Multiple Sewershed Package 14 – Open Cut and Pipe Bursting
Solicitation No.: CO-00365
Job No.: 19-4545

ADDENDUM 4
October 19, 2020

MAP No. 000-000	SHEET 5 OF 48
SECT. No. _____	
DR. JFM CK. JGM JOB No. _____

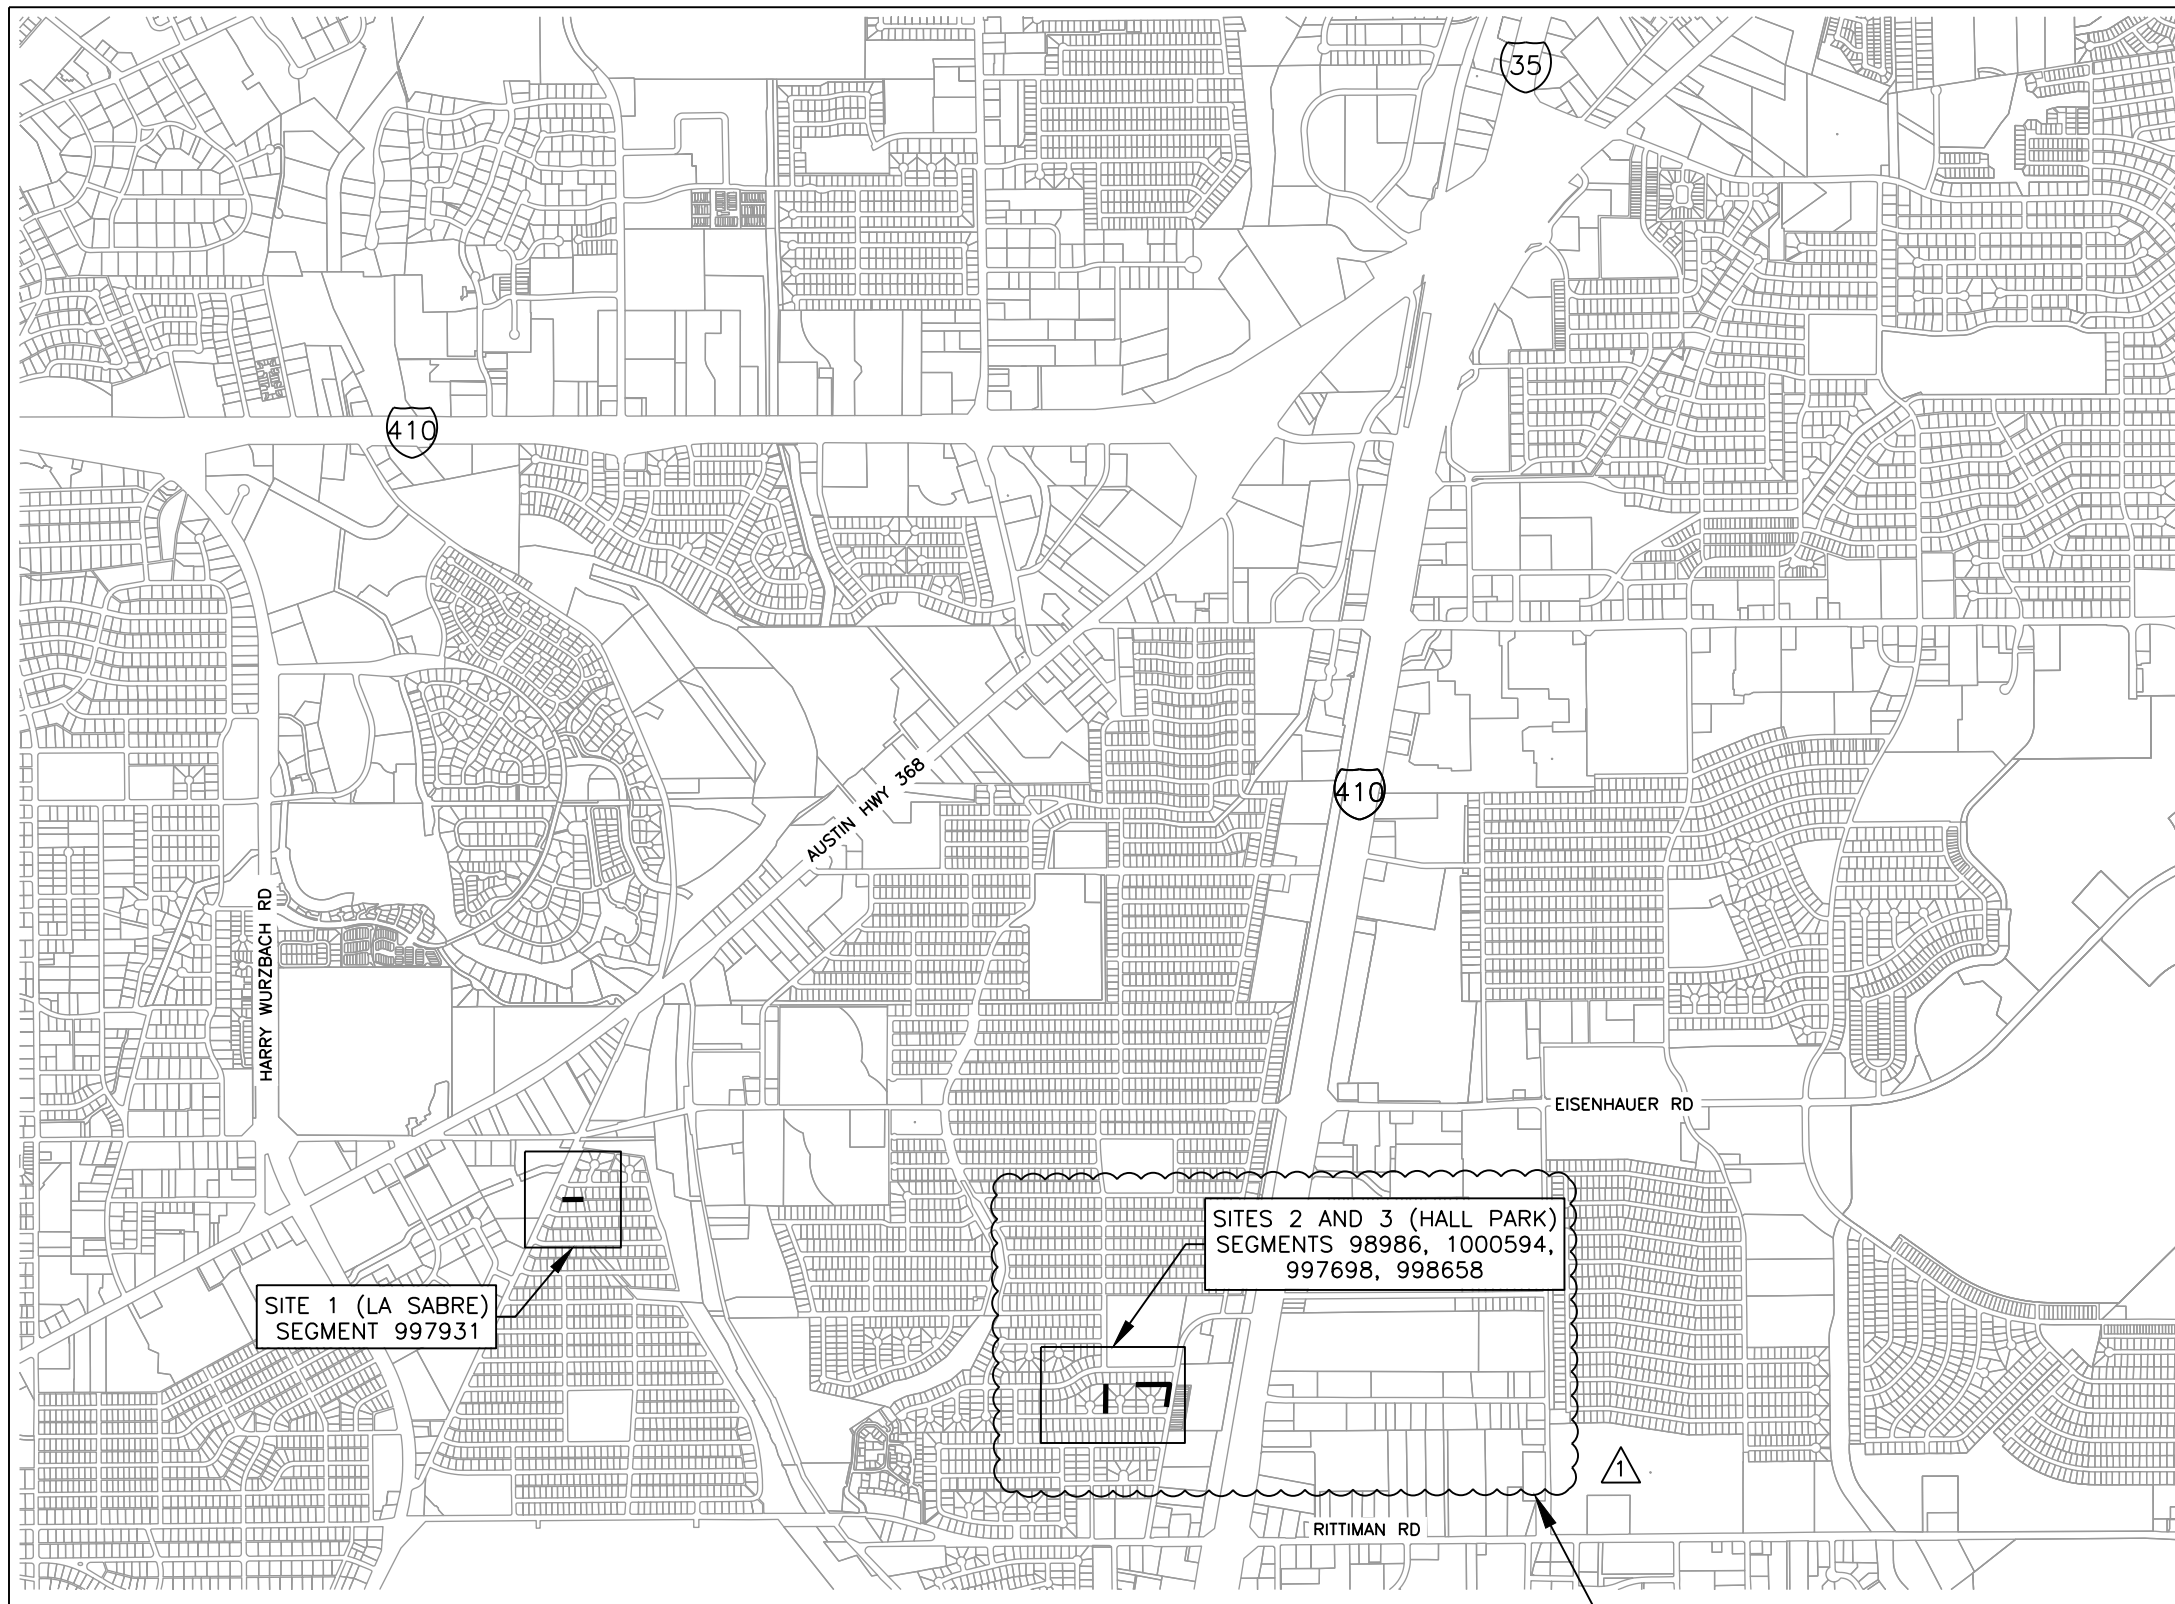
2. Sheets 2, 7, 10, 19, 20, and 21 were revised to indicate the removal of Site 4 from the project.
3. The following updates have been made to the Summary of Quantities on Sheet 5:

- a. Quantity for Bid Item 103.1 Remove Concrete Curb has been **adjusted**.
 - b. Quantity for Bid Item 103.3 Remove Concrete Sidewalks and Driveways has been **adjusted**.

- c. Quantity for Bid Item 502.1 Concrete Sidewalk has been **adjusted**.
 - d. Quantity for Bid Item 503.1 Portland Cement Concrete Driveway has been **adjusted**.

- e. Bid Item 507.5 Chain Link Wire Fence (Vehicular Gates - 8-foot width) has been **added**.
 - f. Quantity for Bid Item 515.1 Topsoil (4" Depth) has been **adjusted**.

- g. Quantity for Bid Item 516.1 Bermuda Sodding has been **adjusted**.
 - h. Quantity for Bid Item 516.2 St. Augustine Sodding has been **adjusted**.
 - i. Bid Item 530.1 Barricades, Signs, and Traffic Handling (Sites 2, 3, & 4 – Hall Park) has been **removed**.

- j. Bid Item 530.1 Barricades, Signs, and Traffic Handling (Sites 2 & 3 – Hall Park) has been **added**.
 - k. Bid Item 864-S1 Bypass Pumping (Sites 2, 3, & 4 Hall Park – 8") has been **removed**.

- l. Bid Item 864-S1 Bypass Pumping (Sites 2 & 3 Hall Park – 8") has been **added**.
 - m. Quantity for Bid Item 550 Trench Excavation Safety Protection has been **adjusted**.

- n. Quantity for Bid Item 848 8" PVC Sanitary Sewer Pipe (SDR 26) (All Depths) has been **adjusted**.
 - o. Quantity for Bid Item 852.1 Sanitary Sewer Manhole (4' Dia) (0'-6' Depth) has been **adjusted**.

- p. Quantity for Bid Item 852.3 Extra Depth Manhole (>6') has been **adjusted**.
 - q. Quantity for Bid Item 854 6" PVC Sanitary Sewer Lateral Pipe (SDR 26) (All Depths) has been **adjusted**.

- r. Quantity for Bid Item 854 Two-Way Sanitary Sewer Clean-out has been **adjusted**.
 - s. Quantity for Bid Item 866 Sewer Main Television Inspection (Pre-Construction) (8" - 15" Dia.) has been **adjusted**.

- t. Quantity for Bid Item 866 Sewer Main Television Inspection (Post-Construction) (8" - 15" Dia.) has been **adjusted**.
 - u. Quantity of Bid Item 6001 Portable Changeable Message Sign has been **adjusted** and payment unit has been **changed** from Lump Sum to Each.

- v. Bid Item 2050 Structure (Shed) Relocation and Deck Adjustment (Site 4 - 4419 Hall Park) has been **removed**.
 - w. Bid Item 2051 Concrete Foundation Removal (Site 4 - 4421 Hall Park) has been **removed**.

- x. Bid Item SS 2010 Removal & Replacement of Fences (All Types, Sizes) (Site 4 - Hall Park) has been **removed**.
4. Sheet 12 was revised to add Bid Item 6001 Portable Changeable Message Sign.

SHEET 15 OF 48

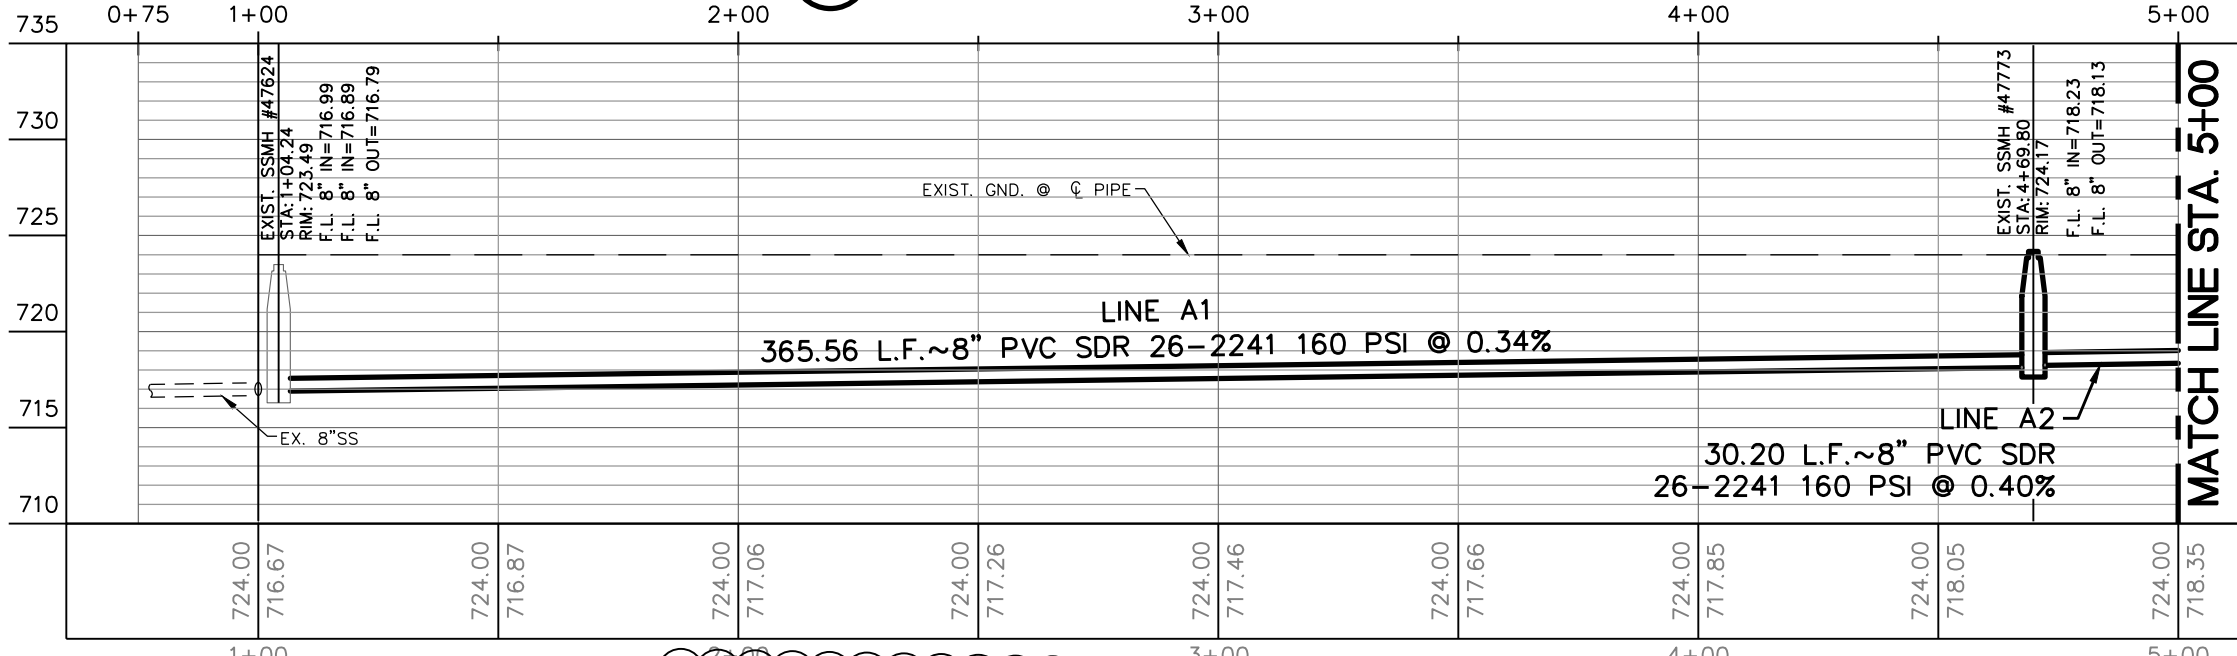
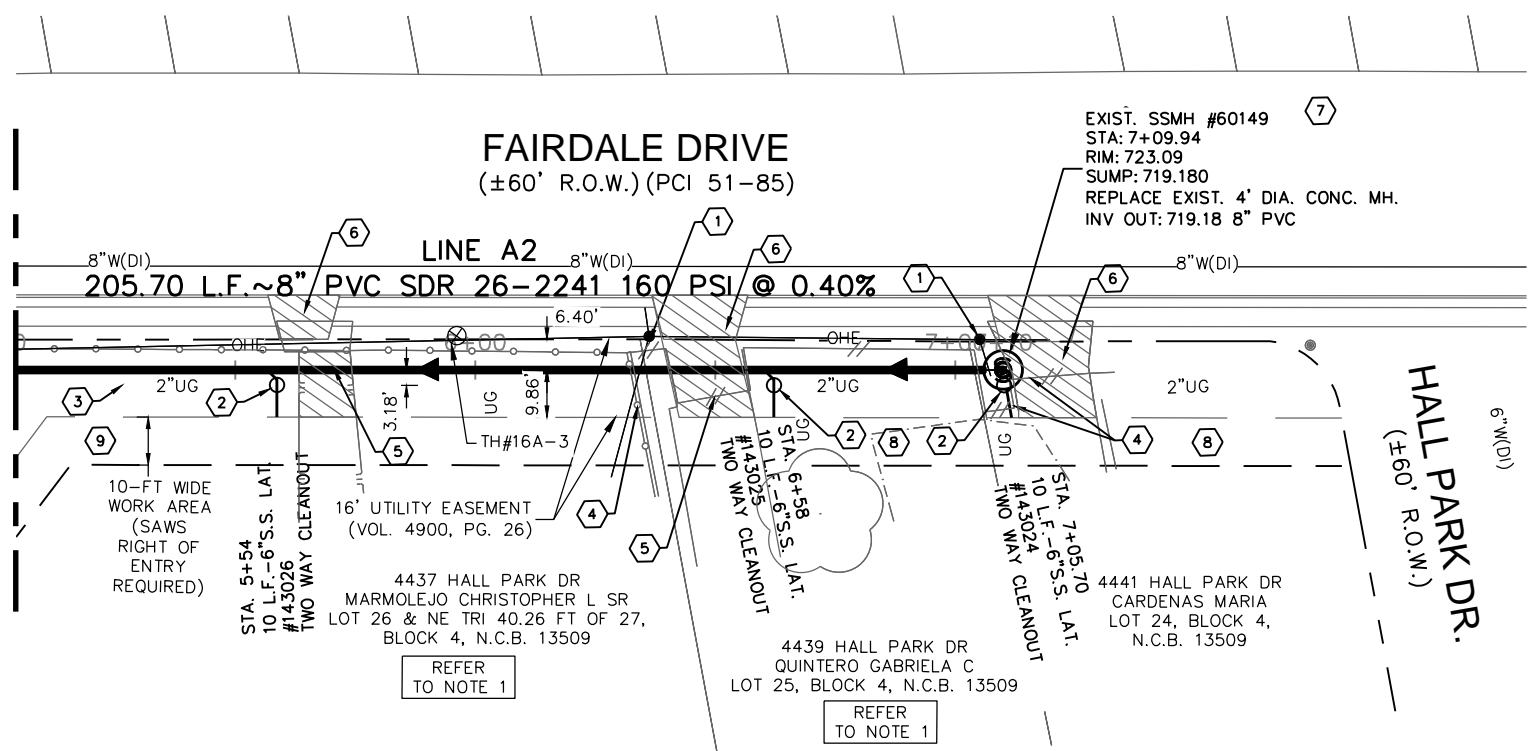
5. The following updates have been made to Sheet 15:
 - a. Revision of Key Note #7
 - b. Addition of Key Notes #10, 11, & 12
 - c. Addition of a call out to replace SSMH #47624

- d. Updates to the Summary of Quantities:
 - i. Bid Item 103.1 Remove Concrete Curb has been **added**.
 - ii. Bid Item 103.3 Remove Concrete Sidewalks and Driveways has been **added**.

- iii. Bid Item 502.1 Concrete Sidewalk has been **added**.
 - iv. Bid Item 503.1 Portland Cement Concrete Driveway has been **added**.
 - v. Bid Item 507.5 Chain Link Wire Fence(Vehicular Gates - 8-foot width) has been **added**.

- vi. Bid Item 515.1 Topsoil (4" Depth) has been **adjusted**.
 - vii. Bid Item 516.2 St. Augustine Sodding has been **adjusted**.
 - viii. Bid Item 530.1 Barricades, Signs, and Traffic Handling (Sites 2 & 3 – Hall Park) has been **added**.

- ix. Bid Item 852.1 Sanitary Sewer Manhole (4' Dia) (0'-6' Depth) has been **adjusted**.
 - x. Bid Item 864-S1 Bypass Pumping (Sites 2 & 3 Hall Park - 8") has been **added**.

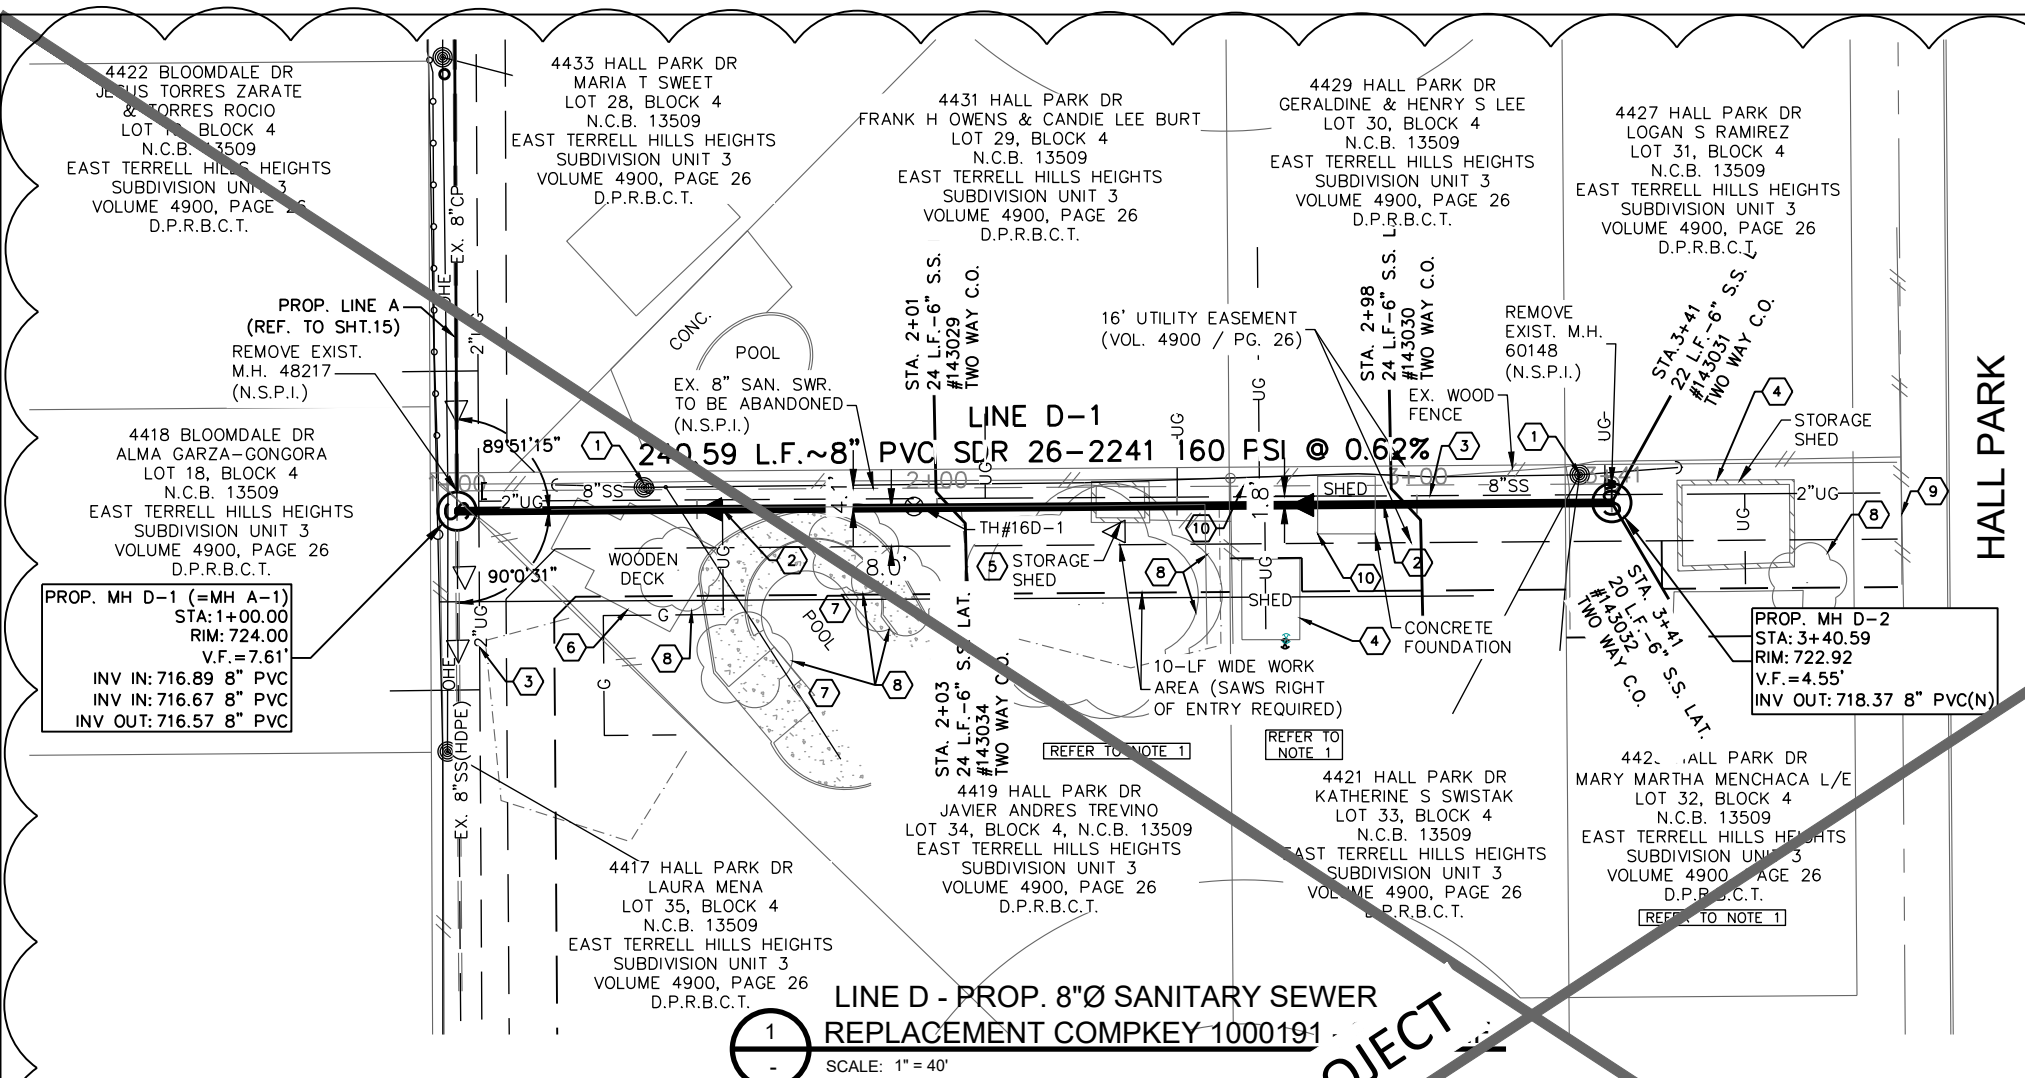
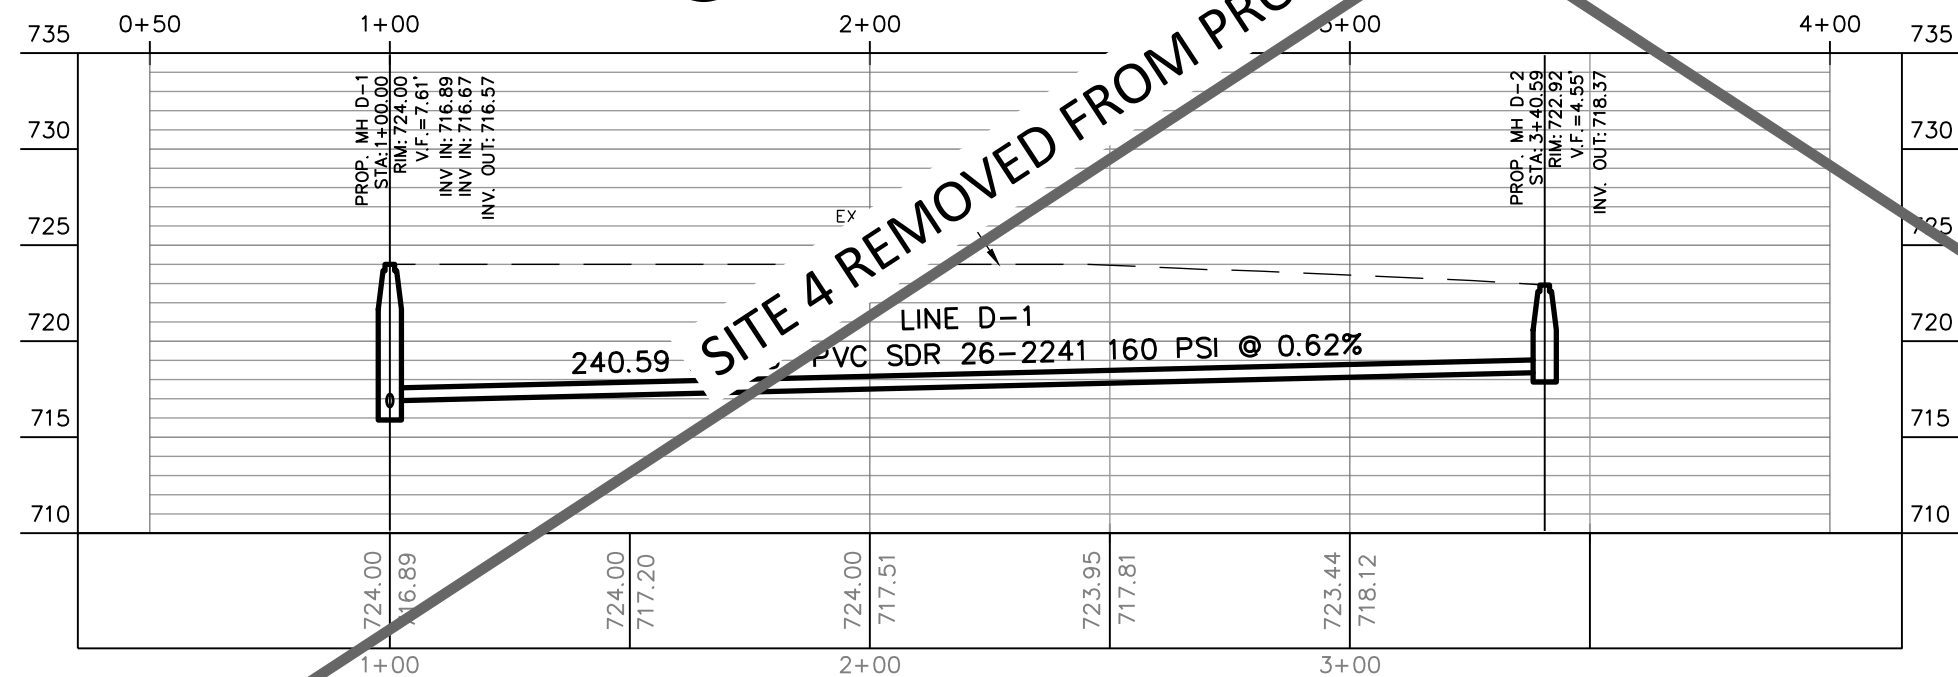
6. The following updates have been made to Sheet 16:
 - a. Addition of Sheet Note #3
 - b. Revision of Key Note #5
